# Access Compliance Report

## Public Rights-of-Way

### (Curb Ramps)

Intersection ID: 53895	Main Street: DALLAS_BAY_RD	Cross Street: HAMILTON_BRIDGE_RD	Location: NW
ADA ID: 3E3676D55535	Ramp Type: Perp	Initial Pass/Fail: Fail	Overall Compliance: No
Severity Score: 21.25			
Codes/Mitigation Info/Possible Solution		Field Measurements/Component Compliance

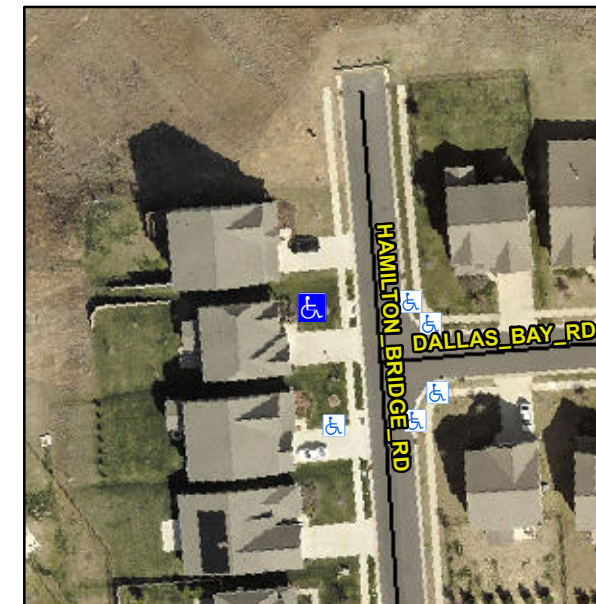
**Not Found, R304.5.1, R304.2.2**

Compliance	Description	Data	Compliance	Description	Data
N/A	Ramp Length (in)	47.5	No	Ramp Slope (%)	11.4
No	Ramp Width (in)	46.5	Yes	Ramp XSlope (%)	0.5
N/A	Flare Type LT	N/A	N/A	Flare Type RT	N/A
N/A	Flare Slope LT (%)	N/A	N/A	Flare Slope RT (%)	N/A
N/A	Flare Traversable LT?	N/A	N/A	Flare Traversable RT?	N/A
N/A	Landing Length (in)	N/A	N/A	DWS Provided?	N/A
N/A	Landing Width (in)	N/A	N/A	DWS Contrast?	N/A
N/A	Landing Slope (%)	N/A	N/A	DWS Length (in)	N/A
N/A	Landing X Slope (%)	N/A	N/A	DWS Full Width?	N/A
N/A	Landing Curb? (Y/N)	N/A	N/A	DWS Offset (in)	N/A
N/A	Shared Landing?	N/A			
N/A	Gutter Ponding?	N/A	N/A	Gutter Slope (%)	N/A
N/A	Gutter Lip Ht (in)	1.5	N/A	Gutter X Slope (%)	N/A
N/A	Painted X Walk1?	No	N/A	Painted X Walk2?	N/A
	X Walk 1 Direction	To E		X Walk 2 Direction	N/A
N/A	X Walk 1 Width (in)	N/A	N/A	X Walk 2 Width (in)	N/A
	X Walk 1 Slope (%)	3.7		X Walk 2 Slope (%)	N/A
	X Walk 1 X Slope (%)	0.7		X Walk 2 X Slope (%)	N/A

**Remove & Replace Entire Ramp.**
